**વિષય :-** Diversion of 0.6174 ha section-4 Forest land for seeking  
appropal for acquiring forest land for contruction of Chuli MR-3  
of morbi branch canal Ta. Dhrangdhra, Surendranagar District in  
Favour of Executive Engineer, Saurashtra branch Canal Dn.6/2  
Surendranagar

Subject: Diversion of 0.6174 ha section-4 Forest land for seeking approval for acquiring forest land for construction of Chuli Mr-3 of Morbi branch canal Ta. Dhrangadhra, Surendranagar district in favor of Executive Engineer, Saurashtra branch canal Dn.6/2 Surendranagar.

### Annexure-35

#### Note on Map showing alternate routes with different colours and justification of selection the proposed route (In case of linear diversion)

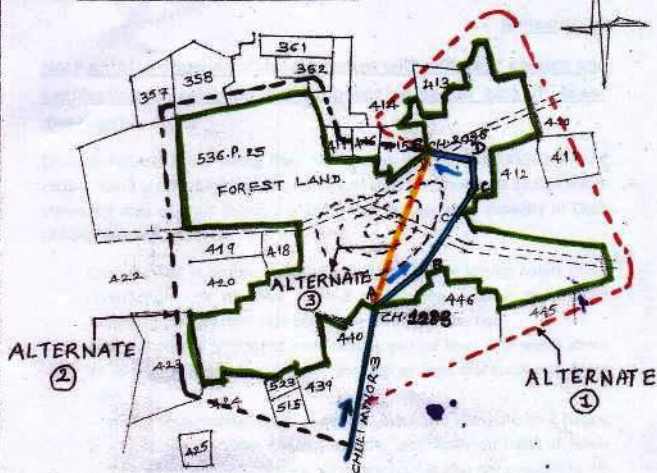
- (1) FRA certificate has been uploaded at its proper place in online proposal and also submitted in hard copies (7 nos) to Deputy Conservator of forests, Surendranagar.
- (2) This remark does not pertain to this office.
- (3) As per remark by region office, Bhopal to explore alternative alignment, justification for selecting present alignment (A-B-C-D-E) is given in Annexure-35 which is uploaded at its proper place in online proposal and also submitted Annexure-35 and maps showing alternatives in hard copies (7 nos) to Deputy Conservator of forests, Surendranagar.

- 1) Chuli minor-3 is contour canal (Contour means line joining points equal levels).Alignment of Chuli minor-3 runs along contour and having command area on right side with respect to flow direction.

- 2) Local hill of 5 to 6m height from existing ground level with width about 30 to 40m is located so it is not possible to align the canal in straight way.

- 3) Alternate no.1 having length of about 2280m and alternate no.2 having length of about 2100m are not feasible technically on basis of levels requirements and bed banking. Alternate no.3 is also not possible as big hill coming on alignment which makes canal in deep cutting.

- 4) Width of proposed canal is 8.54m only ,so 6174 sq.m area is required, but in alternative-3 shown in orange colour is passes through hill of about 5mt.height,so area required is  $723 \times 28.450 = 20570$  sq.m.

- 5) As per most feasible technical alignment with minimum forest land utilization mentioned in map having length 723m is proposed and finalised as most feasible.

Looking to the above facts the only possible feasible alignment marked on map with A-B-C-D-E is the best suitable alignment looking to the topography and command area.
